MISSISSIPPI POWER & LIGHT COMPANY

SUBJECT: Grand Gulf Nuclear Station
Units 1 and 2
Docket Nos. 50-416 and 50-417
File: 0260/0277/L-860.0/L814.1
Re: AECM-81/231; July 1, 1981
Equipment Qualification
NUREG-0588 Evaluation
Supplement 1
AECM-81/335

ATTACHMENT NO. 1
SUMMARY OF RESULTS/FOLLOW-UP PROGRAM
SUPPLEMENT 1

FIGURE 1 MSIV NEGATIVE LEAKAGE CONTROL SYSTEM

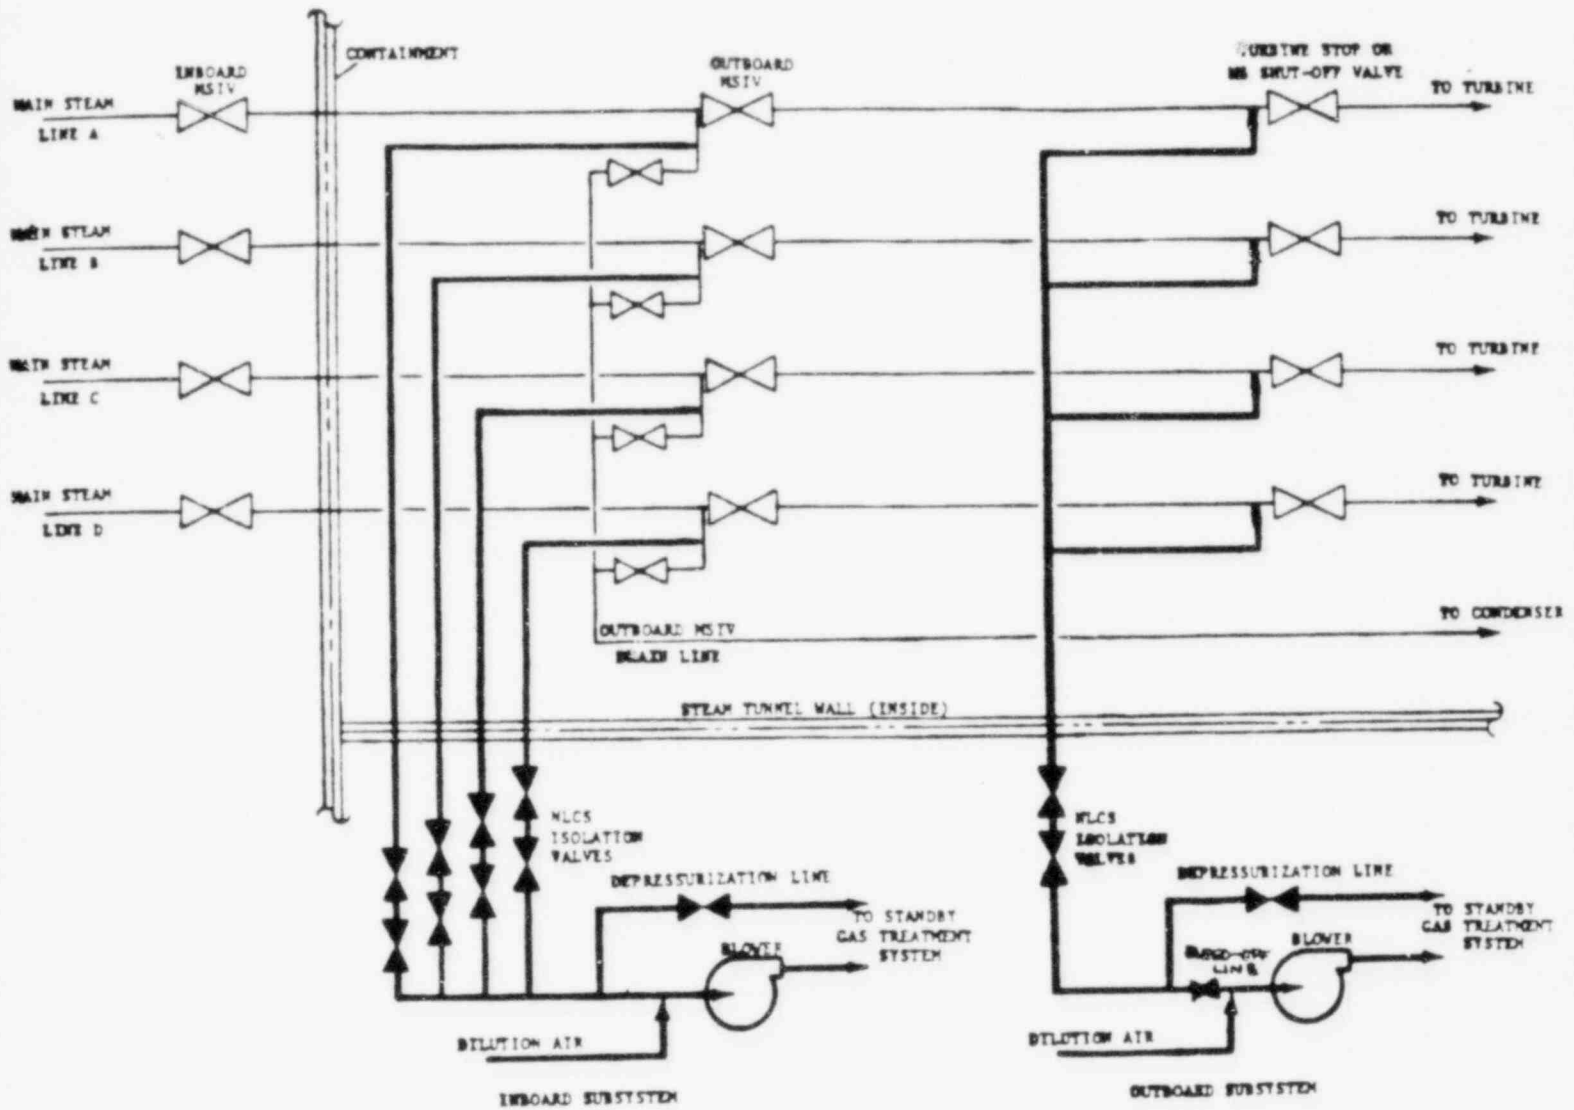
The MSIV Limit Switches used in the MSIV LCS are used to isolate or interlock the LCS depending on the in-board MSIV position indication. The LCS is used following a DBA recirculation line break to collect MSIV seat leakage and directed to the Standby Gas Treatment System in the Auxiliary Building for processing. As shown in the attached figure (Figure 1) there is one LCS between the in-board MSIV and out-board MSIV (outside containment on the out-board MSIV drain line) and a backup LCS outside of the out-board MSIV before the main steam shutoff valve. The MSIV LCS limit switch is on the in-board MSIV.

Major concerns of the MSIV limit switch failure would be exceeding dose limits or pressure integrity of the LCS blower. Since the limit switches are qualified for 30 day operation in the accident environment, the only concern is from 30 to 100 days post accident.

The limiting failure after 30 days would be for the limit switch to erroneously indicate the in-board MSIV valve position open thus isolating the LCS. The limit switch is only on the in-board LCS; thus, the out-board LCS would remain activated even though the in-board LCS will be isolated. Therefore, all seat leakage would be collected by the outboard LCS system maintaining doses below required limits.

The limiting failure after 30 days would be for the limit switch to erroneously indicate the in-board MSIV valve position closed if the MSIV were to fail open. The failure of the in-board valve open would not be a common mode failure since it requires both sufficient air pressure and control logic to open the valve. Thus, the out-board MSIV would remain closed. A failed limit switch erroneously indicating the valve to be closed would prevent the LCS from isolating. The concern is that even though the LCS piping is qualified to approximately 1000 psi, the LCS blower is only qualified for atmospheric pressure. If the in-board MSIV were to open, the line pressure could be as high as 35 psia (with hydrogen recombiners and other equipment actuated). The LCS isolation valves isolate on valve position, high pressure in the steam line (greater than 5 psig) or high flow through the flow element upstream of the blower. Thus, the blower would be isolated even with erroneous valve position indication and hence pressure integrity of the LCS would be maintained.

Test the current generation of NAMCO EA-740 limit switch to obtain a five (5) year qualified life by June 1982 or as soon thereafter as possible.

New Limit Switches will be provided by October 1981 and installed by December 1981. The current generation of limit switches is a NAMCO EA740 Model, which has a qualified life in the normal environment of 400 days and in the accident environment of 30 days according to NUREG-0588 Category II requirements. Since the specifications require 100 days operability in the accident environment, justification is provided for interim operation with the 30 day switches for application in the MSIV Leakage Control System (LCS). The Reactor Protection System (RPS) limit switches require operability less than 30 days; and so consequently, the new switches would meet the requirements of NUREG-0588 Category II.
